ADDENDUM NO. 07
April 16, 2010

Project: **A NEW TRANSPORTATION FACILITY**
Dickinson Independent School District

Bay Project No.: **0806**

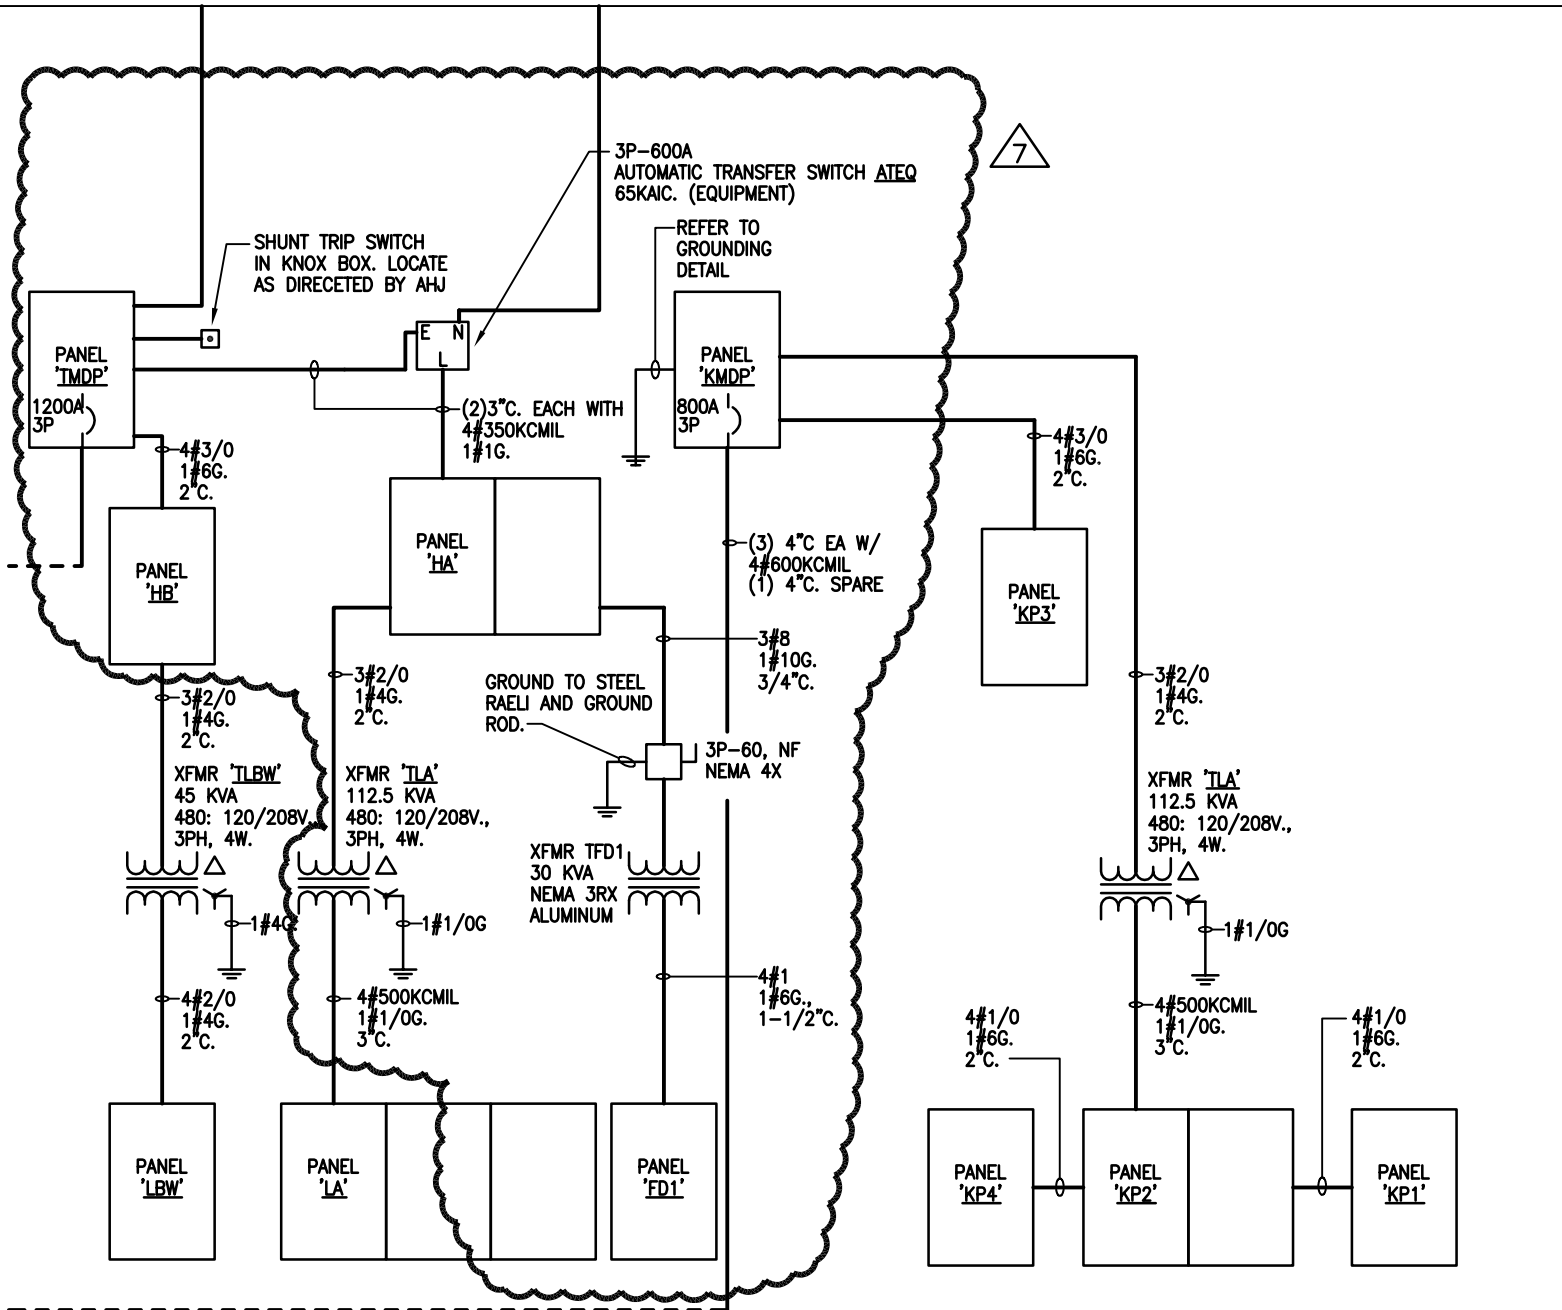
16. Sheet E 5.01 Electrical Notes and Schedules
- A. Add Fixture Type F which shall be Widelite #ILXQL165-HST-208-277-BRC3-ILX-SC4ILXH/P
- B. Refer to Sketches ADD-07-01,02,03 for One-Line.

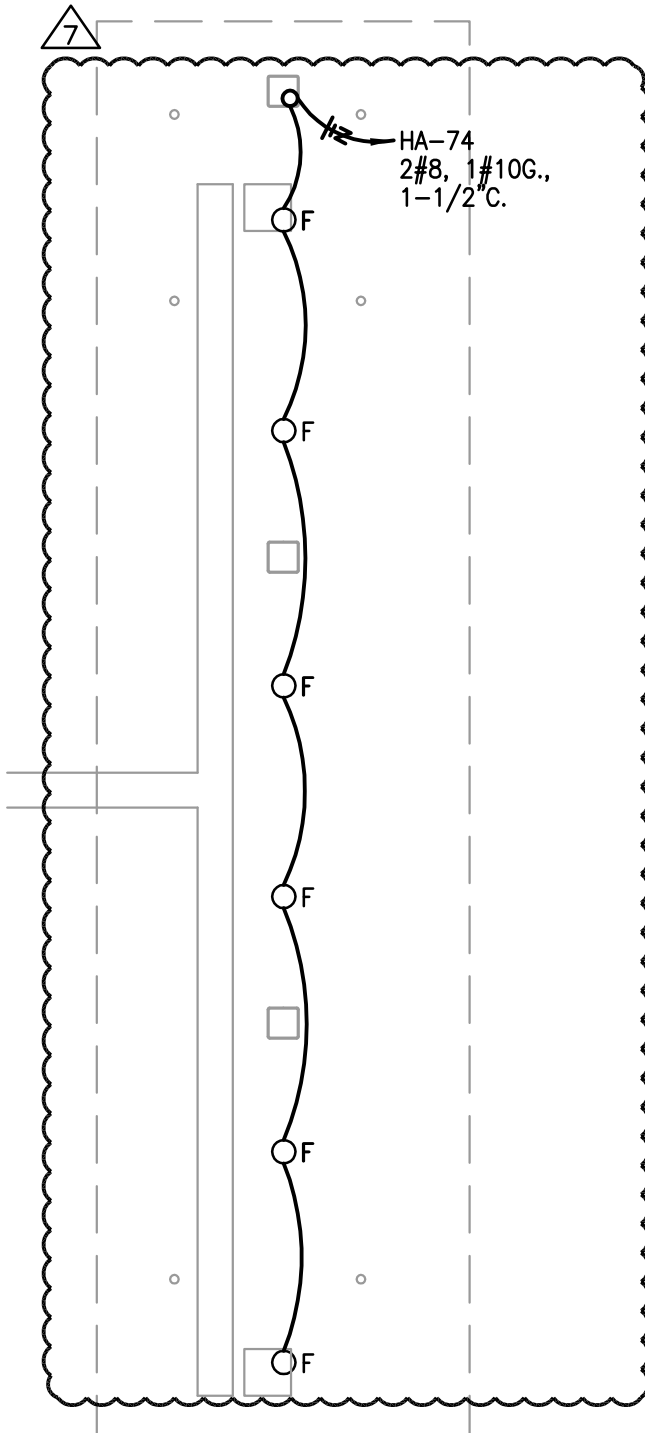
- A. Refer to Sketches **ADD-07-04** and **ADD-07-05** for modifications.
14. Sheet E3.01 Electrical Details
- A. Refer to Sketch **ADD-07-06** for Electrical Equipment Rack Detail.
